OS-299 (10-22)  pennsylvania DEPARTMENT OF TRANSPORTATION www.penndot.pa.gov	TRANSMITTAL LETTER	PUBLICATION: Publication 148						
		DATE: 4/6/2026						
SUBJECT: Revisions to Traffic Standards – Signals TC-8800 Series December 2011 Edition, Change No. 3								
INFORMATION AND SPECIAL INSTRUCTIONS: Incorporate the attached revisions to the December 2011 Edition of Publication 148. These revised Standard Drawings should be adopted on all new and existing designs as soon as possible without affecting any letting schedules and in conjunction with current Publication 408 Specifications. The standards were updated to include a wood post mounting option for Flashing Warning Devices/Border Lit Signs. Additions, deletions, and revisions specific to each Standard and Sheet are as follows: <table border="1" data-bbox="152 961 1425 1140"> <thead> <tr> <th>STANDARD</th> <th>SHEET</th> <th>DESCRIPTION OF CHANGES</th> </tr> </thead> <tbody> <tr> <td>TC-8808</td> <td>1</td> <td>"FLASHING WARNING DEVICE WOOD POST MOUNTING" Sheet added to standards.</td> </tr> </tbody> </table>			STANDARD	SHEET	DESCRIPTION OF CHANGES	TC-8808	1	"FLASHING WARNING DEVICE WOOD POST MOUNTING" Sheet added to standards.

SHEET 1 OF 10
TC-8801

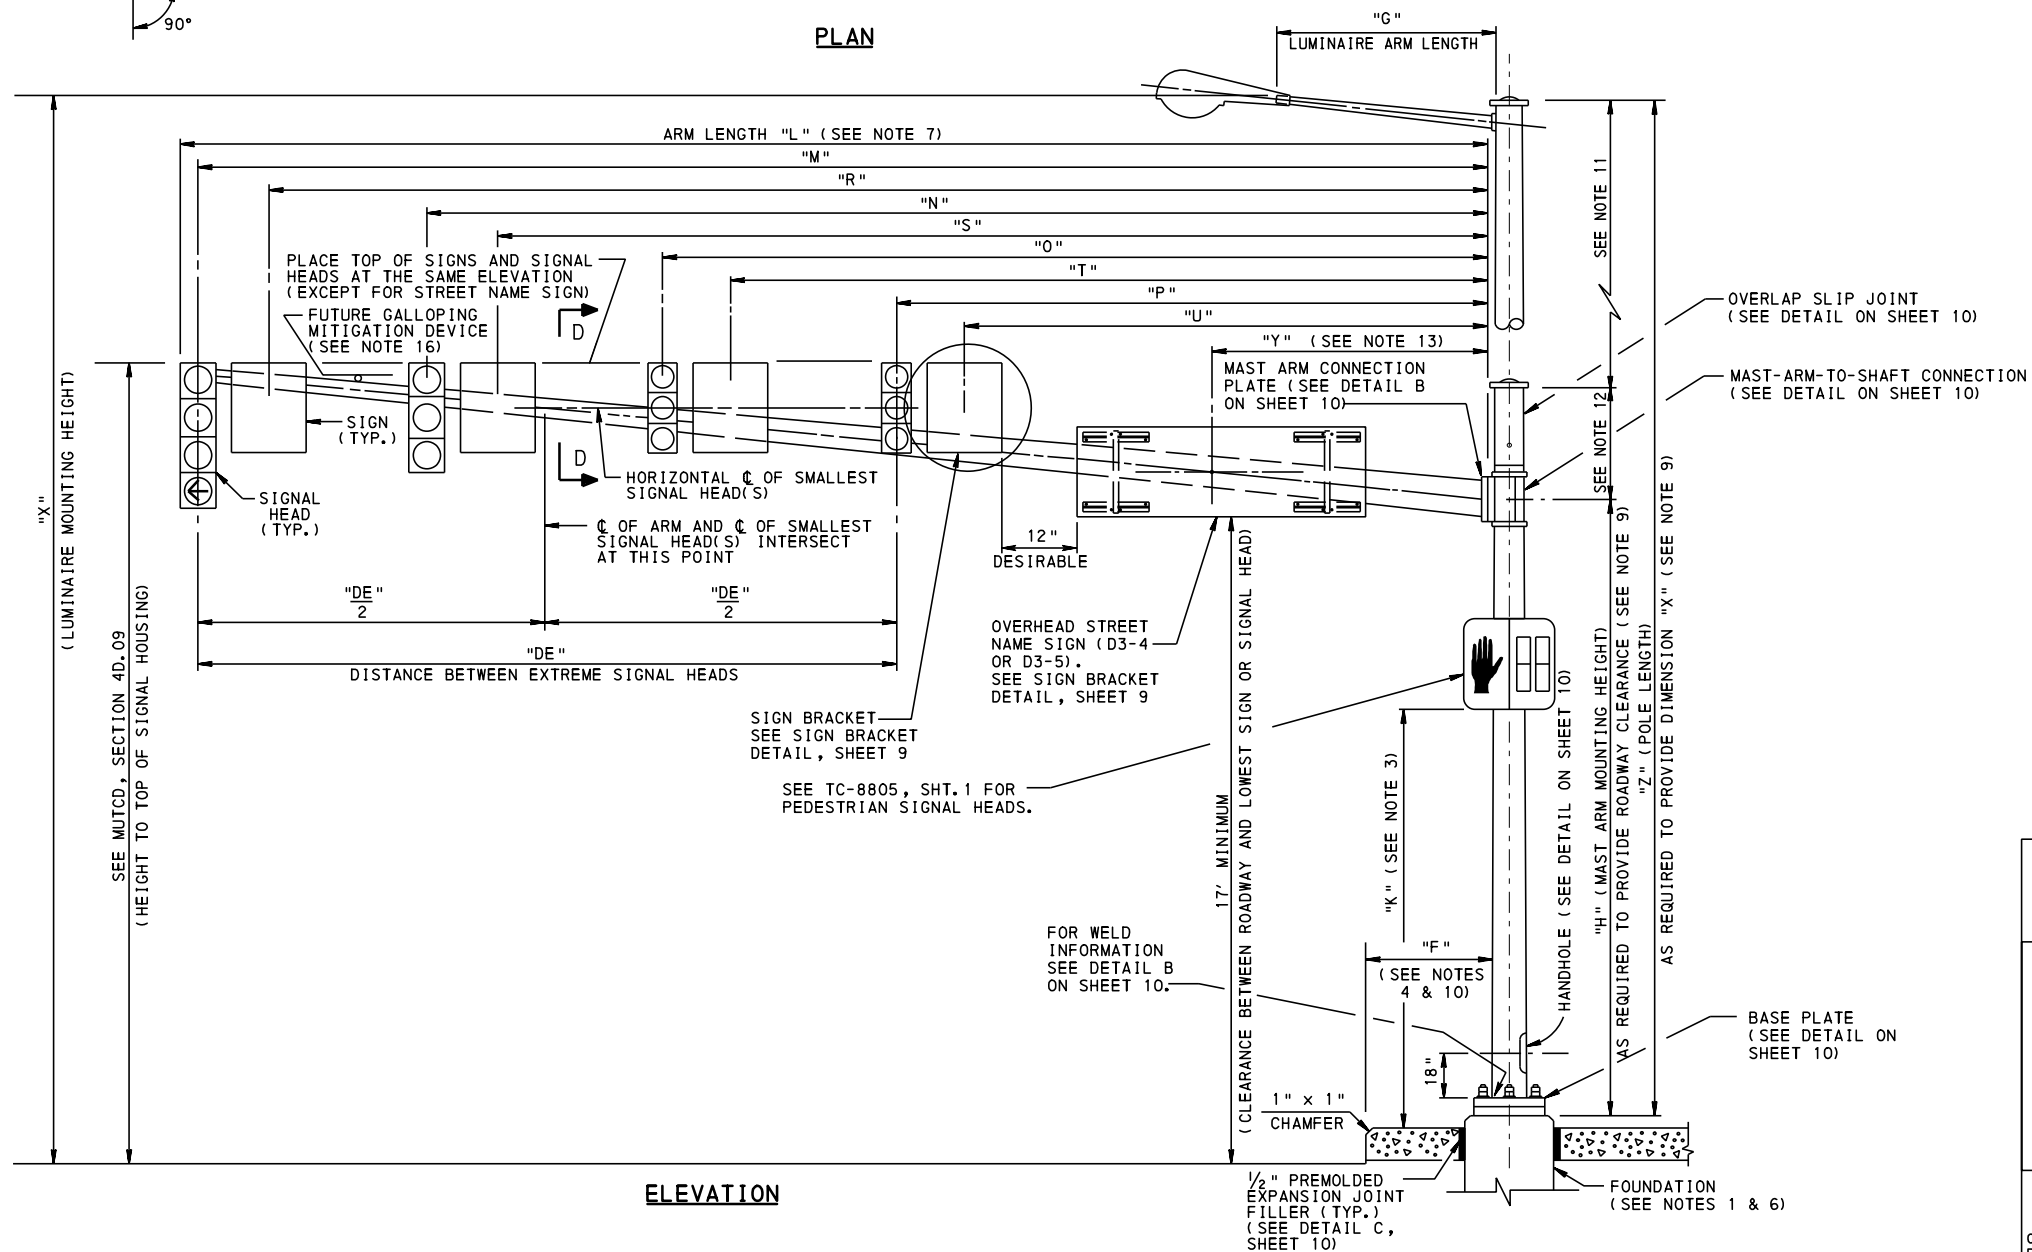
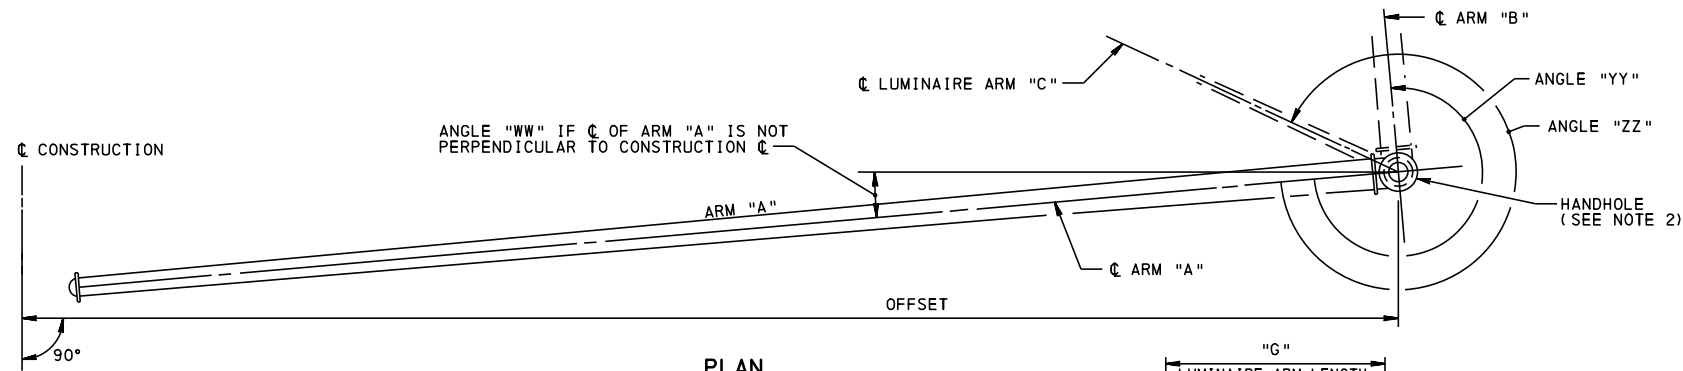
<table><tr> <th>STANDARD</th> <th>SHEET</th> <th>DESCRIPTION OF CHANGES</th> </tr><tr> <td data-bbox="152 1075 349 1906">TC-8801</td> <td data-bbox="349 1075 487 1906">1</td> <td data-bbox="487 1075 1424 1906"> Updated Mast Arm Details as follows: -Revised Handhole callout leader location on Plan View of mast arm to match location of handhole depicted in Elevation View -Revised bolt pattern on Elevation View of mast arm pole base plate. Bolts depicted now represent six bolt pattern implemented in 2011 TC-8801 updates. Updated Notes as follows: - Revised Note 7 from “ARMS LESS THAN 31’ WILL BE ONE SECTION” to “ARMS 30’ OR LESS WILL BE ONE SECTION” - Revised second sentence of Note 16 from “PROVIDE GALLOPING MITIGATION DEVICE IN ACCORDANCE WITH PUB 408, SECTION 1104.02(b) IF THE MAXIMUM DISPLACEMENT (MAX. POSITIVE TO MAX. NEGATIVE) AT THE MAST ARM TIP EXCEEDS 8”.” to “PROVIDE GALLOPING MITIGATION DEVICE IN ACCORDANCE WITH MITIGATION DEVICE DETAIL ON SHEET 10 IF THE MAXIMUM DISPLACEMENT (MAX. POSITIVE TO MAX. NEGATIVE) AT THE MAST ARM TIP EXCEEDS 8”.” </td> </tr></table>

STANDARD	SHEET	DESCRIPTION OF CHANGES	TC-8801	1	Updated Mast Arm Details as follows: -Revised Handhole callout leader location on Plan View of mast arm to match location of handhole depicted in Elevation View -Revised bolt pattern on Elevation View of mast arm pole base plate. Bolts depicted now represent six bolt pattern implemented in 2011 TC-8801 updates. Updated Notes as follows: - Revised Note 7 from “ARMS LESS THAN 31’ WILL BE ONE SECTION” to “ARMS 30’ OR LESS WILL BE ONE SECTION” - Revised second sentence of Note 16 from “PROVIDE GALLOPING MITIGATION DEVICE IN ACCORDANCE WITH PUB 408, SECTION 1104.02(b) IF THE MAXIMUM DISPLACEMENT (MAX. POSITIVE TO MAX. NEGATIVE) AT THE MAST ARM TIP EXCEEDS 8”.” to “PROVIDE GALLOPING MITIGATION DEVICE IN ACCORDANCE WITH MITIGATION DEVICE DETAIL ON SHEET 10 IF THE MAXIMUM DISPLACEMENT (MAX. POSITIVE TO MAX. NEGATIVE) AT THE MAST ARM TIP EXCEEDS 8”.”	TC-8801	2	Updated Strain Pole Details as follows:
STANDARD	SHEET	DESCRIPTION OF CHANGES									
TC-8801	1	Updated Mast Arm Details as follows: -Revised Handhole callout leader location on Plan View of mast arm to match location of handhole depicted in Elevation View -Revised bolt pattern on Elevation View of mast arm pole base plate. Bolts depicted now represent six bolt pattern implemented in 2011 TC-8801 updates. Updated Notes as follows: - Revised Note 7 from “ARMS LESS THAN 31’ WILL BE ONE SECTION” to “ARMS 30’ OR LESS WILL BE ONE SECTION” - Revised second sentence of Note 16 from “PROVIDE GALLOPING MITIGATION DEVICE IN ACCORDANCE WITH PUB 408, SECTION 1104.02(b) IF THE MAXIMUM DISPLACEMENT (MAX. POSITIVE TO MAX. NEGATIVE) AT THE MAST ARM TIP EXCEEDS 8”.” to “PROVIDE GALLOPING MITIGATION DEVICE IN ACCORDANCE WITH MITIGATION DEVICE DETAIL ON SHEET 10 IF THE MAXIMUM DISPLACEMENT (MAX. POSITIVE TO MAX. NEGATIVE) AT THE MAST ARM TIP EXCEEDS 8”.”									
TC-8801	2	Updated Strain Pole Details as follows:

STANDARD
TRAFFIC SIGNAL SUPPORT
STRAIN POLE

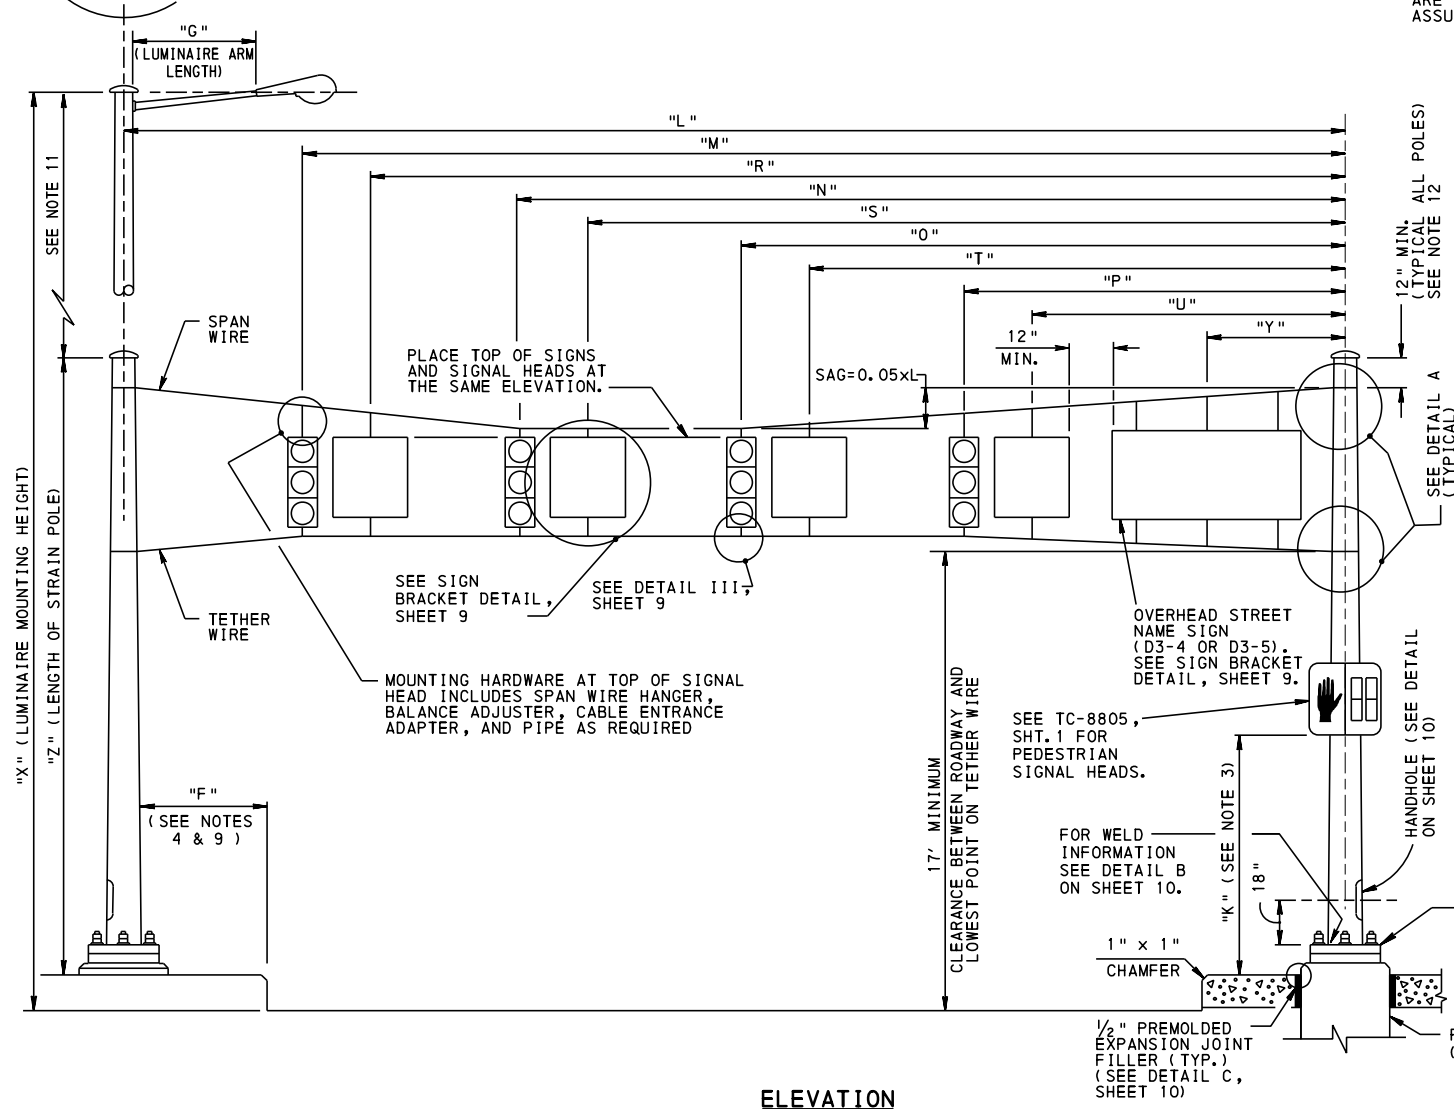
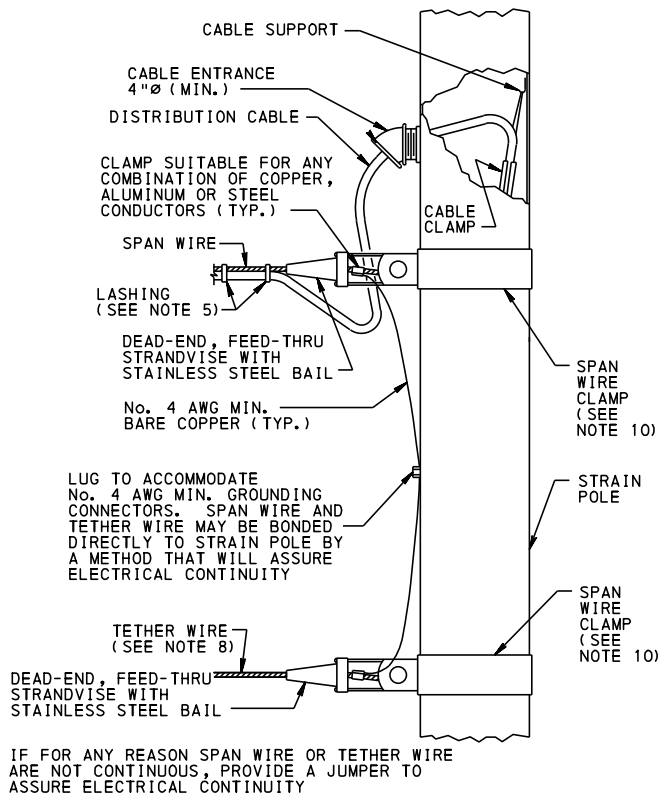
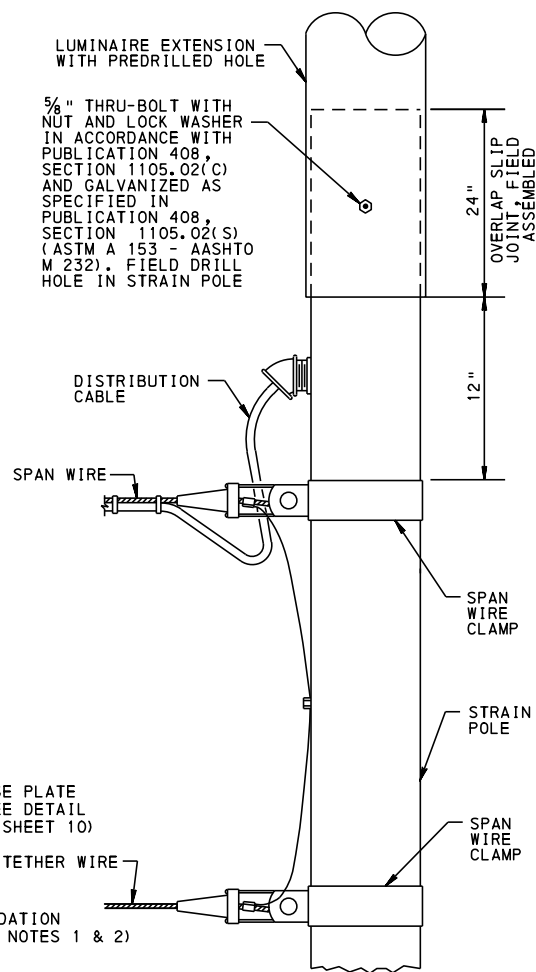
TC-8801	2	- Revised from "AS REQUIRED TO PROVIDE DIMENSION "H" (SEE NOTE 9)" to "H" (MAST ARM MOUNTING HEIGHT.". - Removed "(SEE NOTE 9)" callout. Updated Strain Pole Details as follows: Updated Elevation View of strain pole as follows: - Revised from "Angle "Y"" to "Angle "YY"" - Revised from "Angle "Z"" to "Angle "ZZ"" - Revised from "15' MNIMUM (SEE NOTE 9)" to "17' MINIMUM CLEARANCE BETWEEN ROADWAY AND LOWEST POINT ON TETHER WIRE.". -Removed "(SEE NOTE 9)" callout.	
TC-8801	3	Updated Anchor Bolt Detail as follows: Depicted a washer underneath of the leveling nut	
TC-8801	4	Updated Traffic Signal Support Foundation Type A - Notes as follows: Added Note 8 – "EMBANKMENT SLOPE AS ILLUSTRATED IN PUBLICATION 72M (RC-83M) SHEET 3 OF 3. 2:1 MAXIMUM SLOPE. STEEPER SLOPES REQUIRE SPECIAL DESIGN."	
TC-8801	5	Updated Traffic Signal Support Mast Arm & Pedestal – Mast Arm Foundation notes as follows: Added Note 4 – "EMBANKMENT SLOPE AS ILLUSTRATED IN PUBLICATION 72M (RC-83M) SHEET 3 OF 3. 2:1 MAXIMUM SLOPE. STEEPER SLOPES REQUIRE SPECIAL DESIGN."

<table><tr> <th>STANDARD</th> <th>SHEET</th> <th>DESCRIPTION OF CHANGES</th> </tr><tr> <td data-bbox="152 1906 349 2009">TC-8801</td> <td data-bbox="349 1906 487 2009">2</td> <td data-bbox="487 1906 1424 2009">Updated Strain Pole Details as follows:</td> </tr></table>

TRAFFIC SIGNAL SUPPORT
FOUNDATION TYPE B

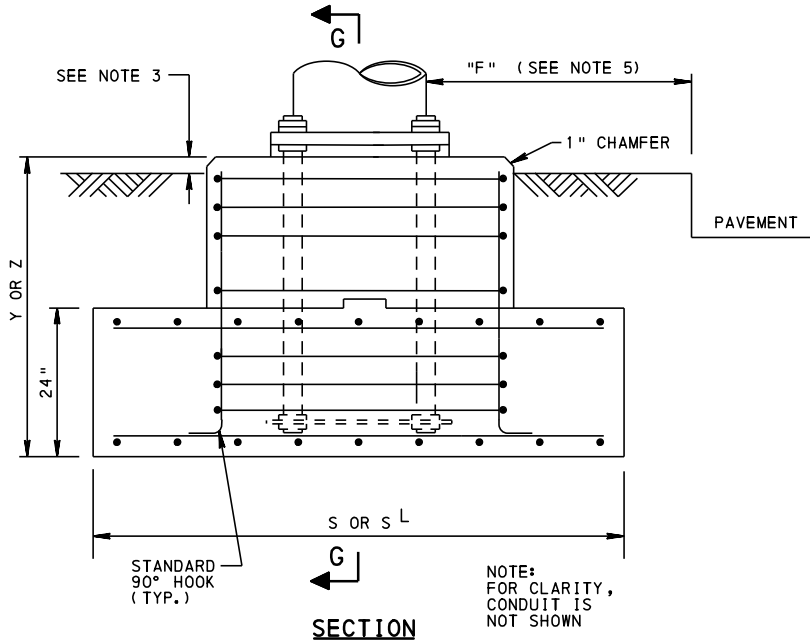
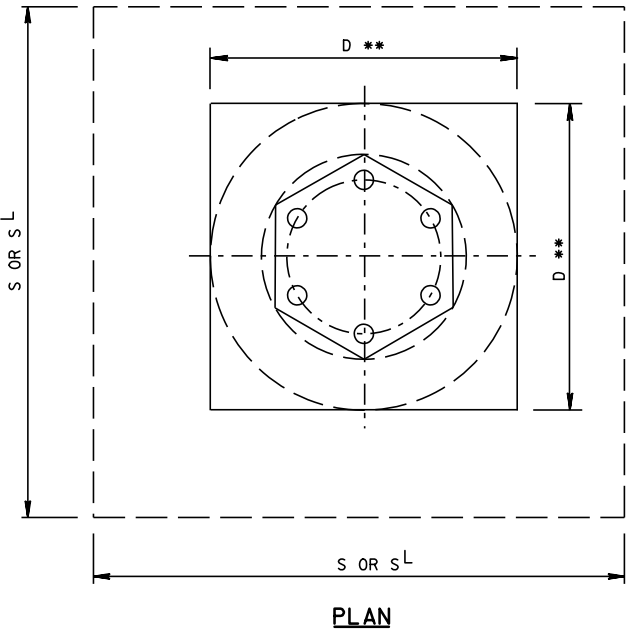
TC-8801	8	Updated Type B Foundation Section G-G Detail as follows: -Removed "(SEE NOTE 7)" from "GALVANIZED WIRE MESH OR GROUT" callout . Updated Notes as follows: - Revised the first sentence of Note 3 from "IN A PAVED AREA, PLACE THE TOP OF FOUNDATION FLUSH WITH THE SURFACE OF THE ADJACENT PAVEMENT" to "IN A SIDEWALK AND PAVED AREA, PLACE THE TOP OF FOUNDATION FLUSH WITH THE SURFACE OF THE ADJACENT PAVEMENT" - Removed Note 7 - Renumbered Note 8 to Note 7	
TC-8801	9	Updated Sign Bracket – Mast Arm Detail as follows: -Revised "STAINLESS STEEL BAND CONFORMING TO PUBLICATION 408, SECTION 1103.11(n)." callout to "STAINLESS

CONNECTION DETAIL

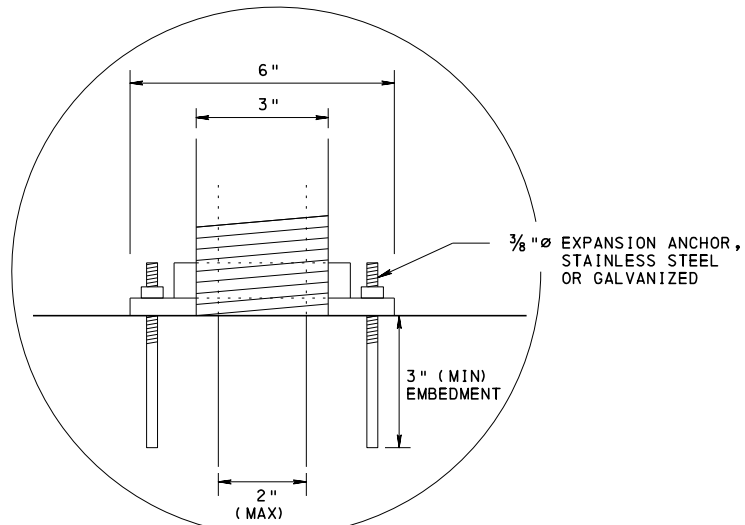
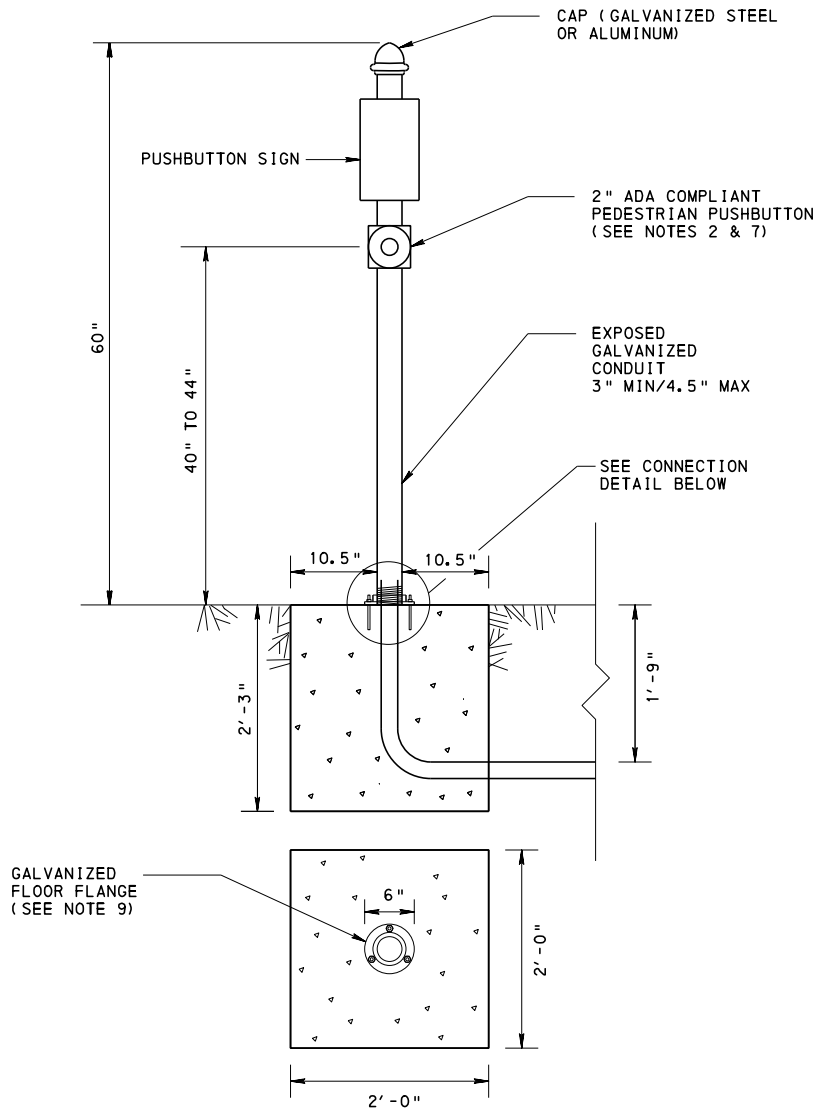
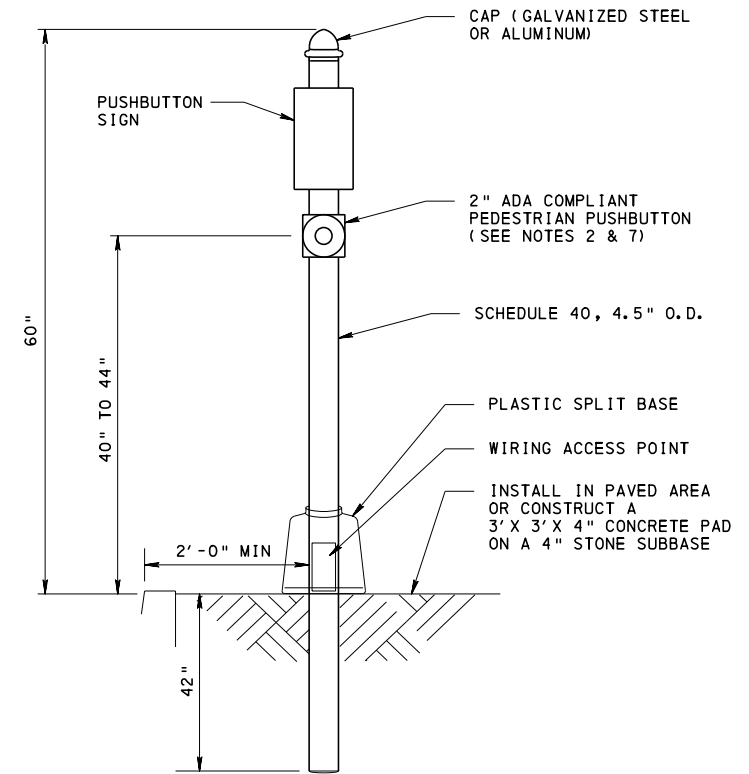
TC-8801	6	Updated Traffic Signal Support Strain Pole Foundation Type A– Strain Pole Foundation notes as follows: Added Note 3 – "EMBANKMENT SLOPE AS ILLUSTRATED IN PUBLICATION 72M (RC-83M) SHEET 3 OF 3. 2:1 MAXIMUM SLOPE. STEEPER SLOPES REQUIRE SPECIAL DESIGN."	
TC-8803	2	Updated Pedestrian Pushbutton Mounting Details Type A and Type B as follows: - Revised "GALVANIZED RIGID STEEL CONDUIT" callout to "GALVANIZED RIGID STEEL CONDUIT 3" MIN/4.5" MAX." -For type A and B Foundations Blocks detail and Connection Detail- Added- "SEE NOTE 9." Updated Notes as follows:

TC-8803	3	- Added Note 9 – “USE AN APPROPRIATELY SIZED FLANGE TO CORRESPOND WITH THE POLE SIZE THAT IS SELECTED. CONNECTION DETAIL CORRESPONDS TO 3” POLE.”. - Added Note 10- “FOR TYPE A AND B FOUNDATIONS, CONDUIT INSTALLATION IN CONCRETE BLOCKS SHALL BE CENTERED AND AS SPECIFIED IN DIMENSIONS.”. Updated Pedestrian Pushbutton Mounting Details Type D and Type E as follows: -Revised “EXPOSED GALVANIZED CONDUIT” callout to “EXPOSED GALVANIZED CONDUIT 3” MIN/4.5” MAX.”. - For type D and E Foundations View A-A - Added- “SEE NOTE 9.”. Updated Notes as follows: - Added Note 9 – “USE AN APPROPRIATELY SIZED FLANGE TO CORRESPOND WITH THE POLE SIZE THAT IS SELECTED. VIEW A-A DETAIL CORRESPONDS TO 3” POLE.”.	
TC-8804	1	Updated Service Type A and B Details as follows: Revised “2” CONDUIT (MIN.)” callout to “CONDUIT (SIZE PER UTILITY.”. Updated Notes as follows: Revised Note 5 from “PROVIDE ALL SERVICE CONDUITS OF THE HDG RIGID METALLIC TYPE WITH WATERTIGHT CONDUIT HUBS” to “PROVIDE ALL SERVICE CONDUITS OF THE MATERIAL APPROVED BY THE UTILITY AND ENSURE WATERTIGHT”.
